工程指示 / 要求簡箋(E.I.)

工程指示編號：EI / 8779 / 25

工程名稱：將軍澳日出康城 11

工程項目：幕牆浴室 T1-T3 AB 單位 橫料加做鋁板 地盤用

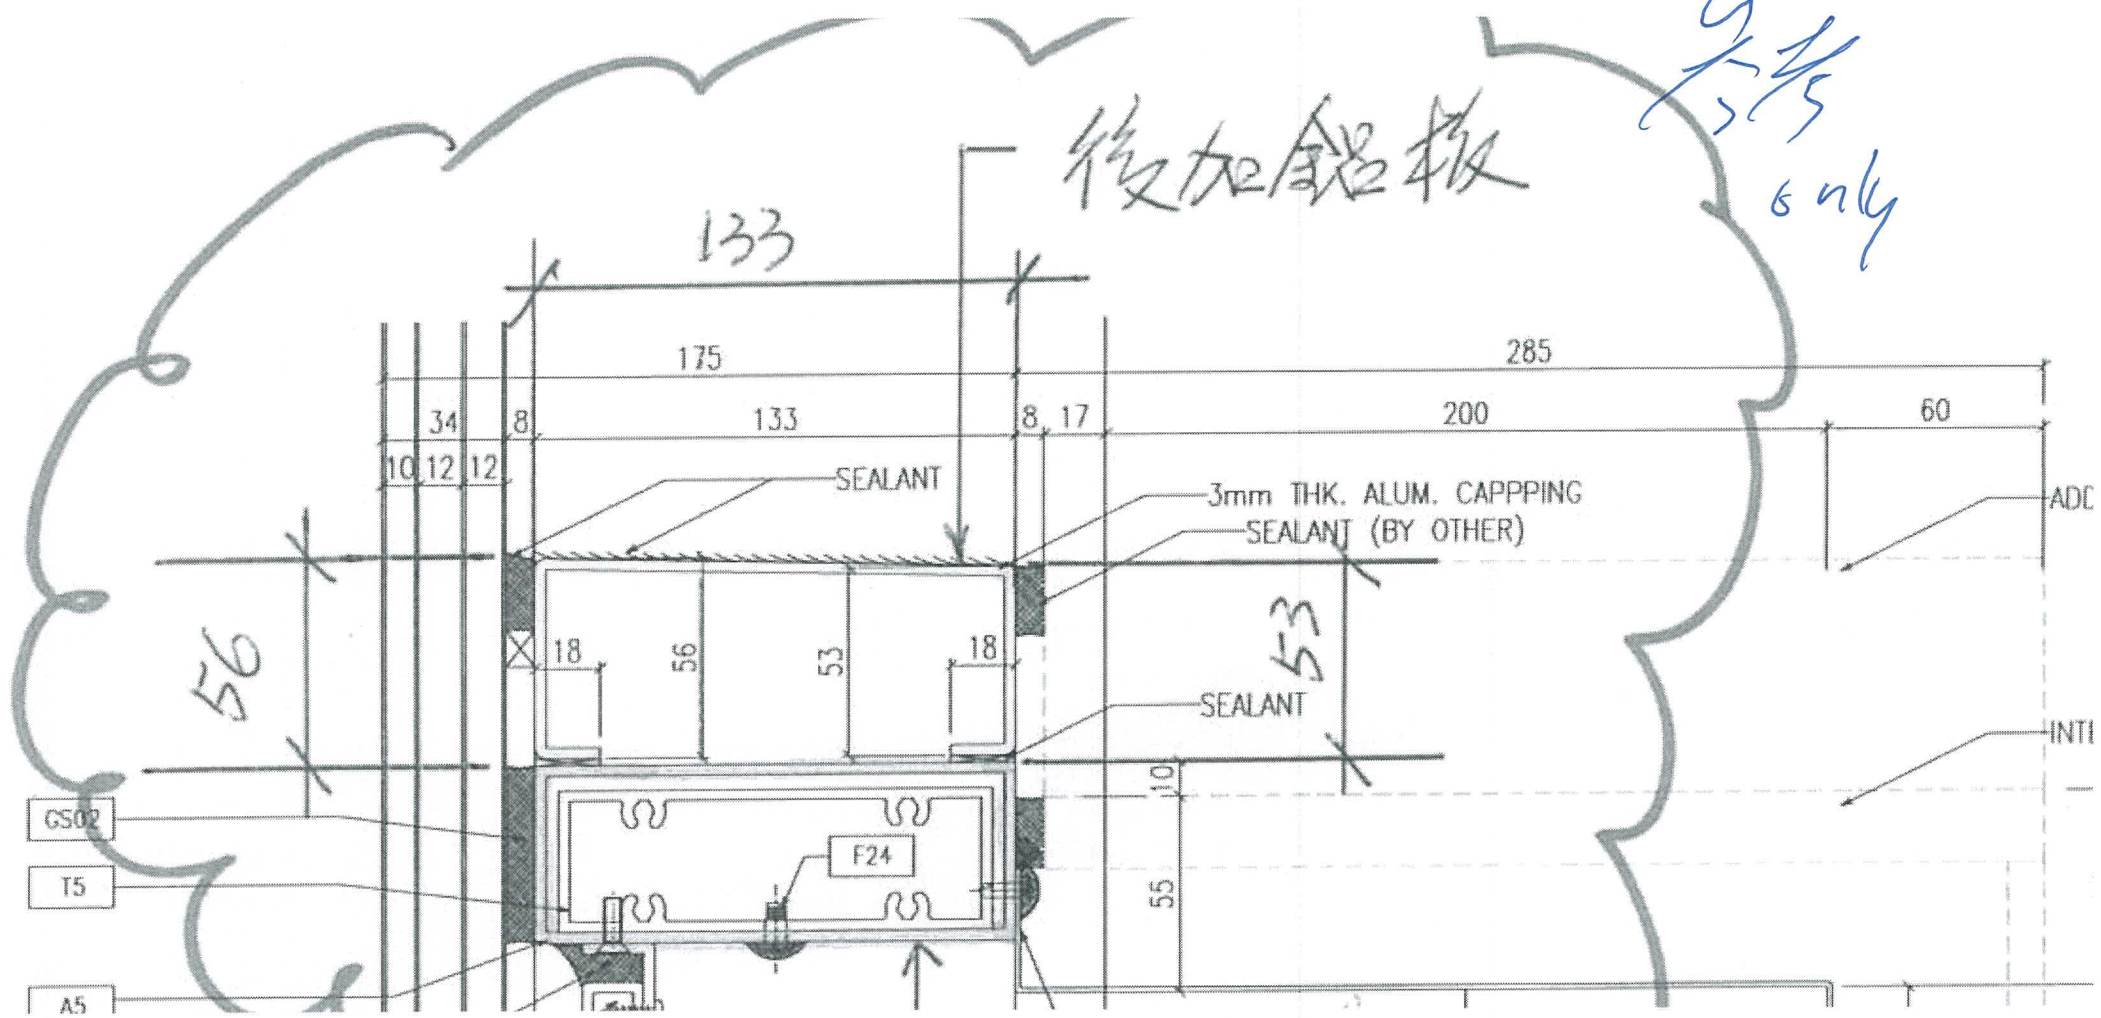
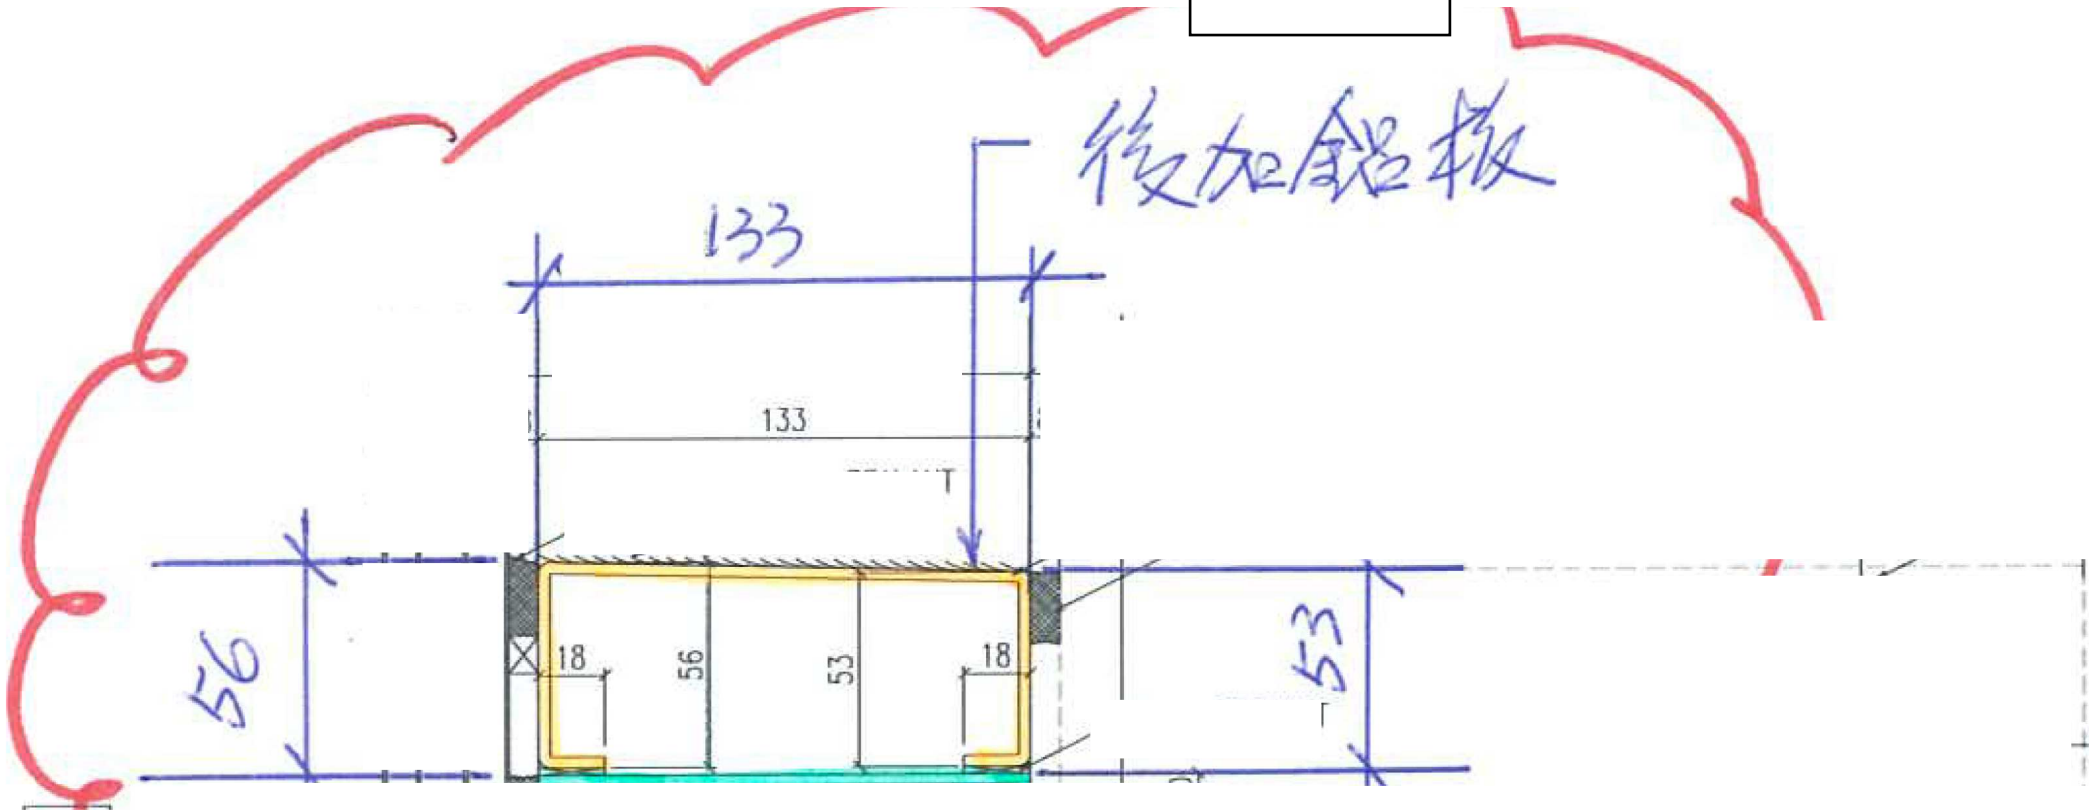
物料編號	L=	數量
T1 Bath -133	T1 564mm	49支
T2 Bath -134	T2 514mm	53支
T3 Bath -135	T3 514mm	53支

後加鋁板

3mm 厚
噴
(PVF2
ECD3x10099S-
XF1)

物料編號	L=	數量
T1 Bath -133	T1 564mm	49支
T2 Bath -134	T2 514mm	53支
T3 Bath -135	T3 514mm	53支

後加鋁板

3mm 厚
噴
(PVF2
ECD3x10099S-
XF1)

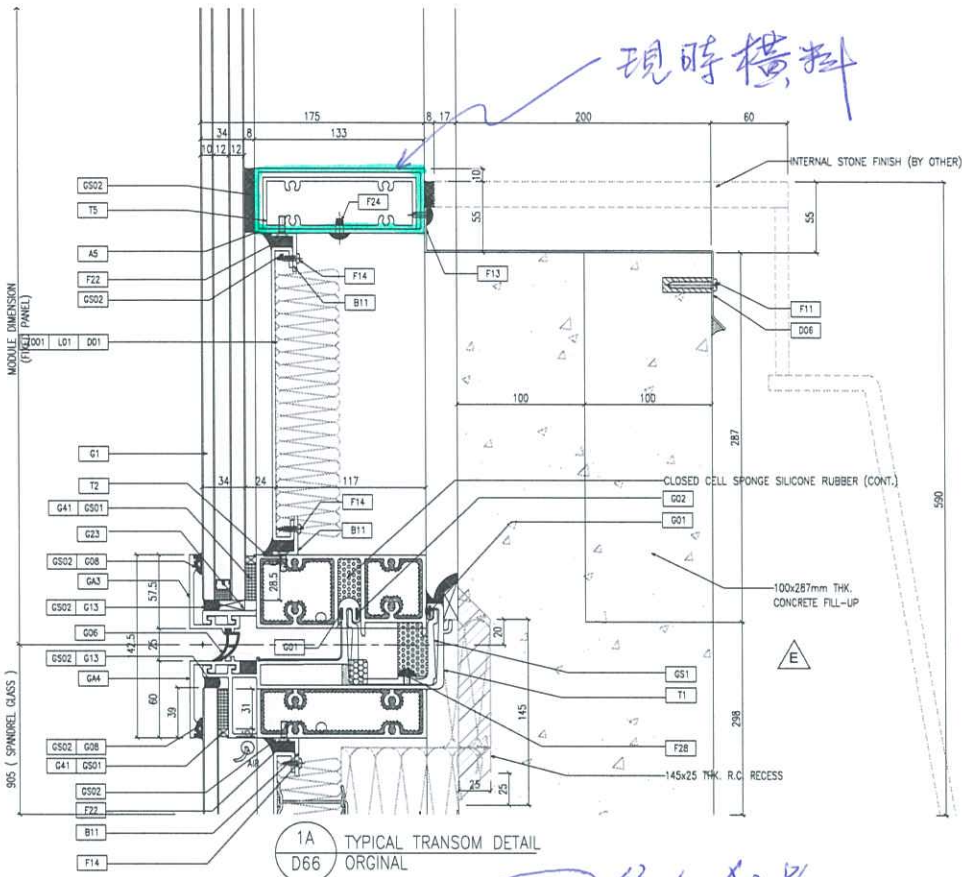
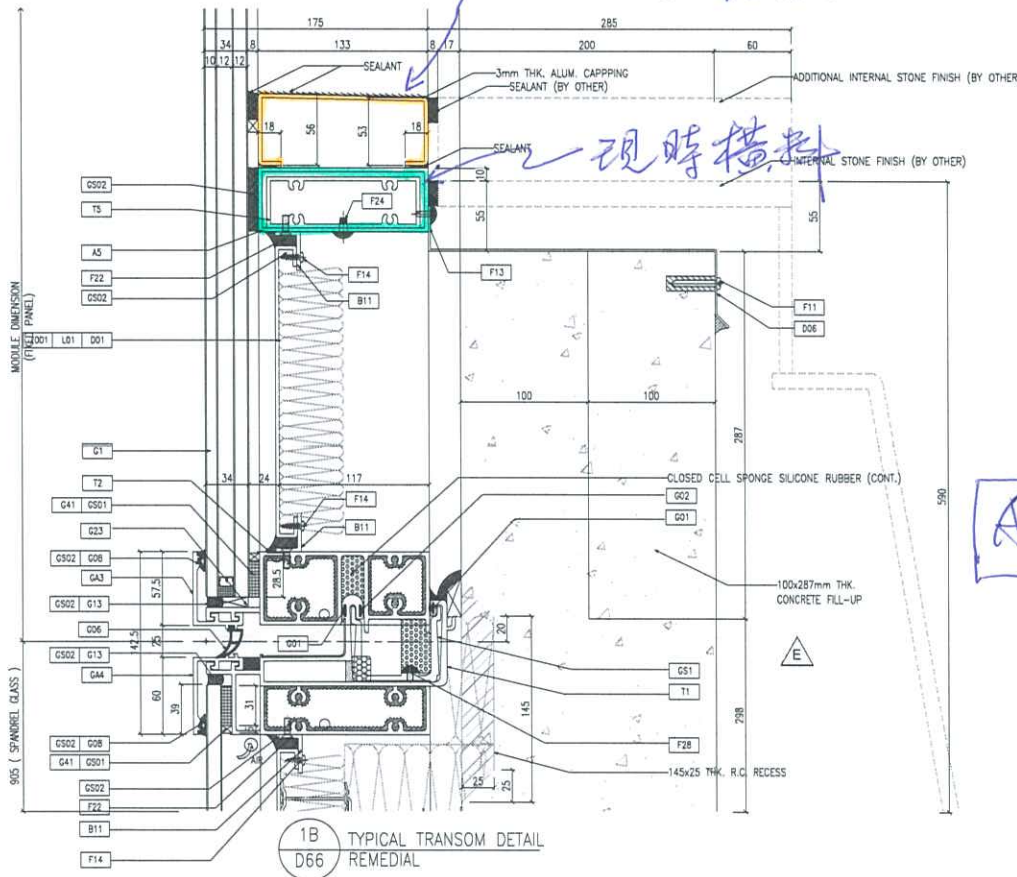
Before

After

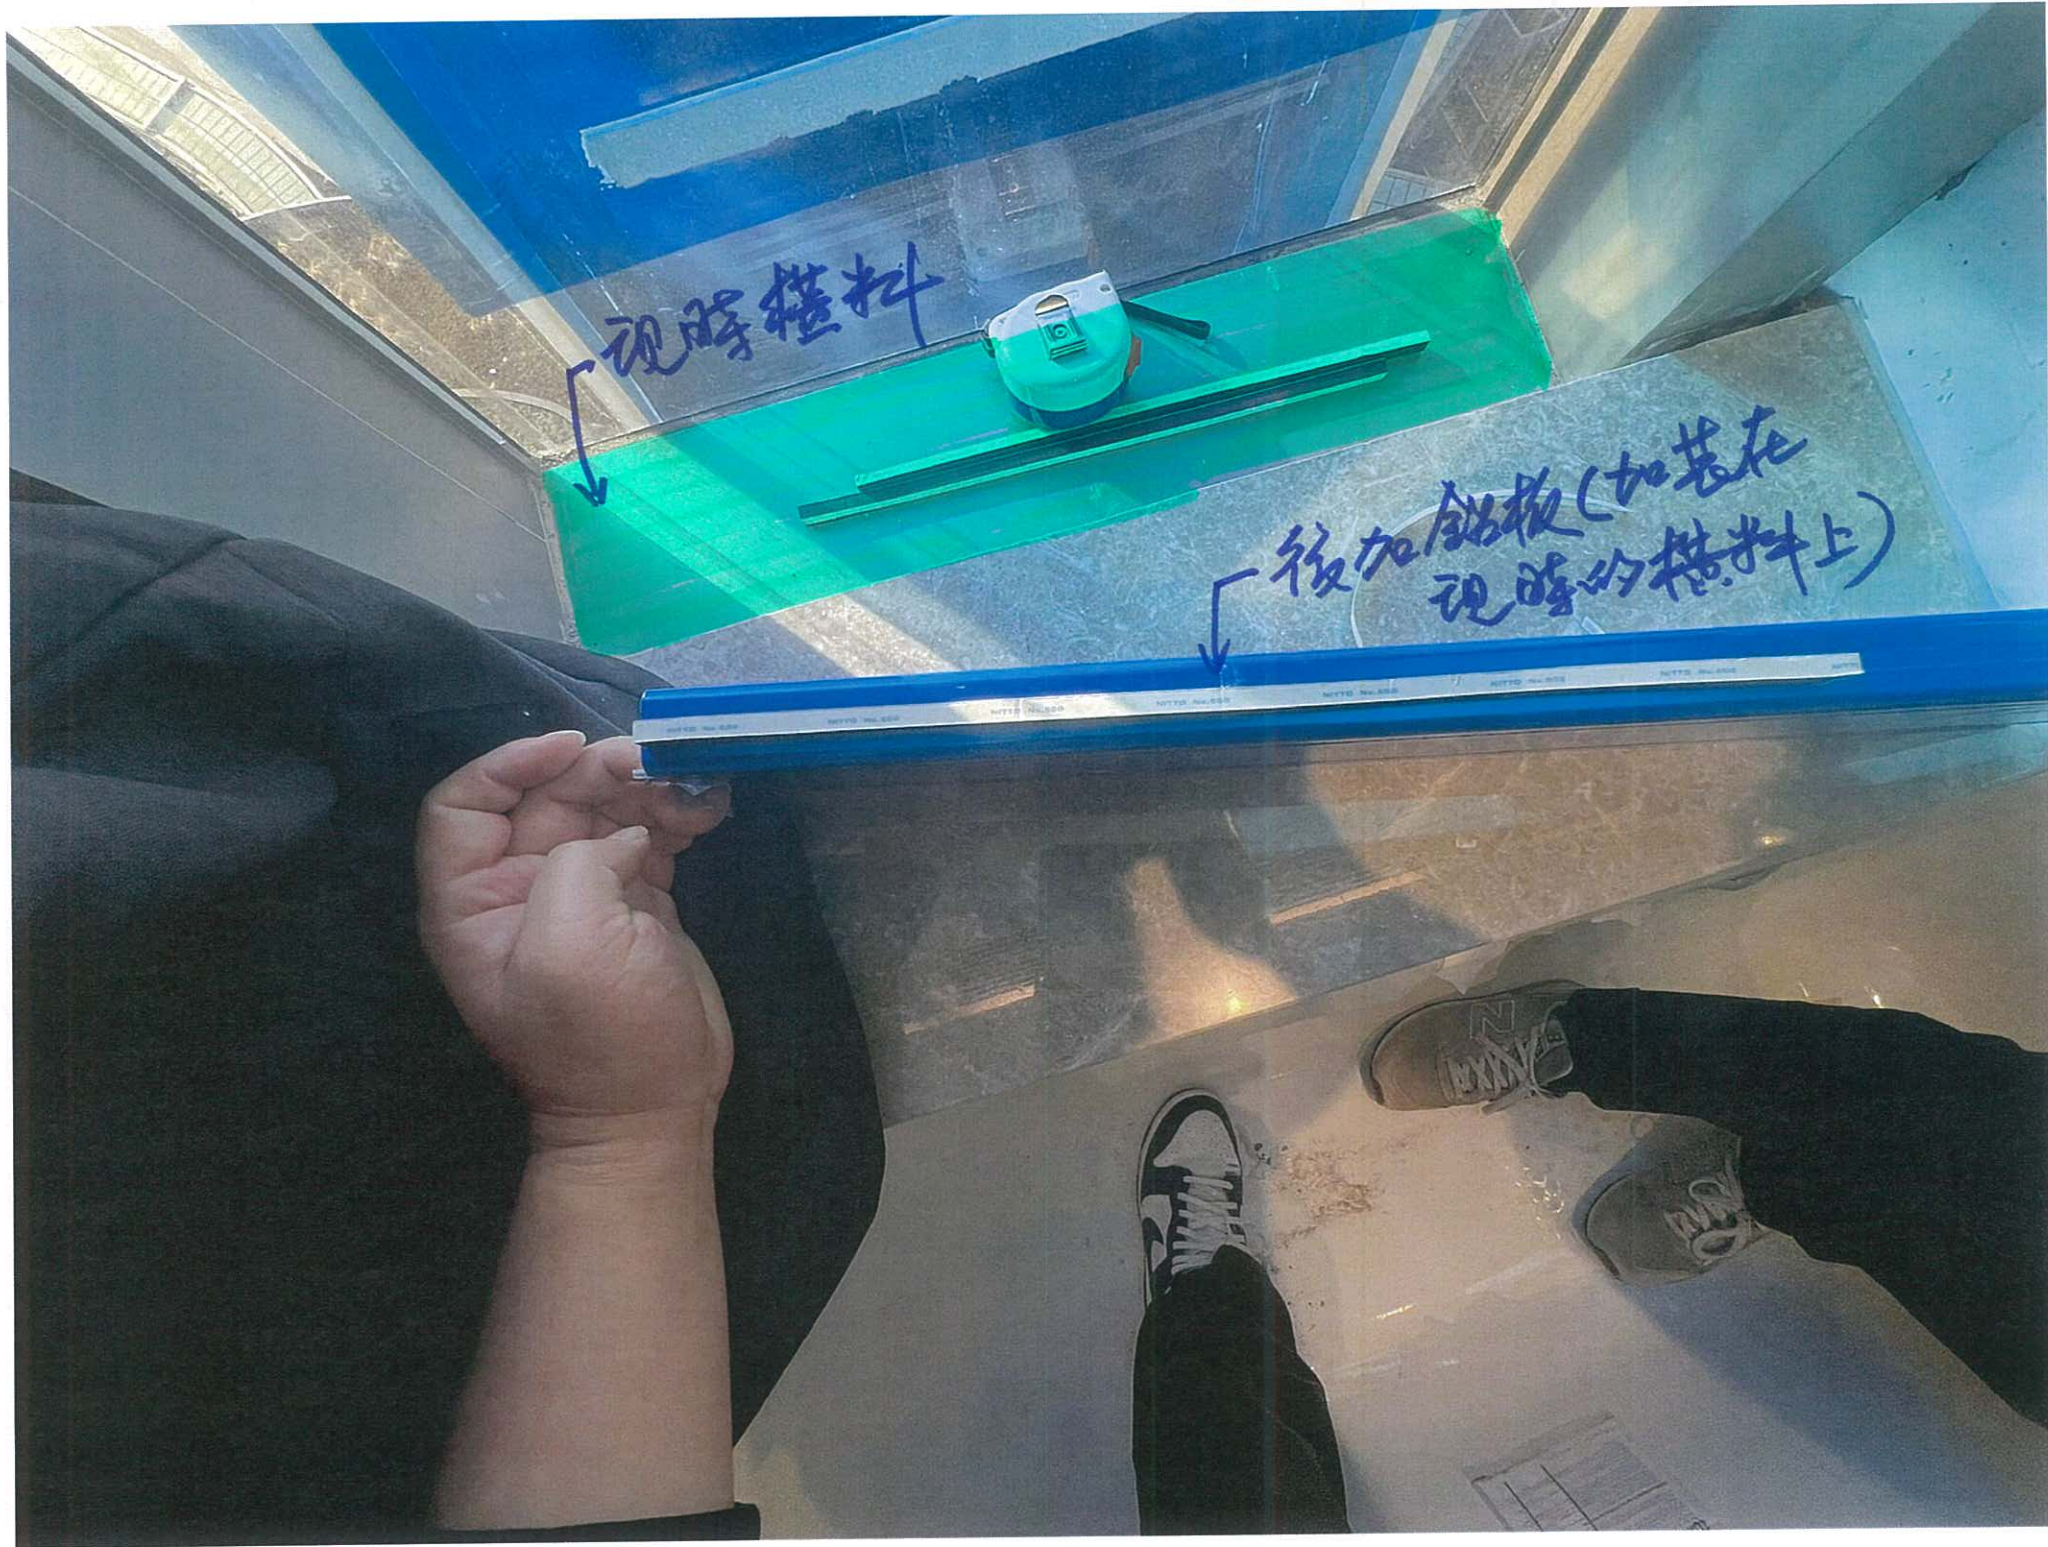
現時橫料

視時標料

後加鉛板(加蓋在視時的標料上)

後加鋁板 (加蓋在現時的橫料上)
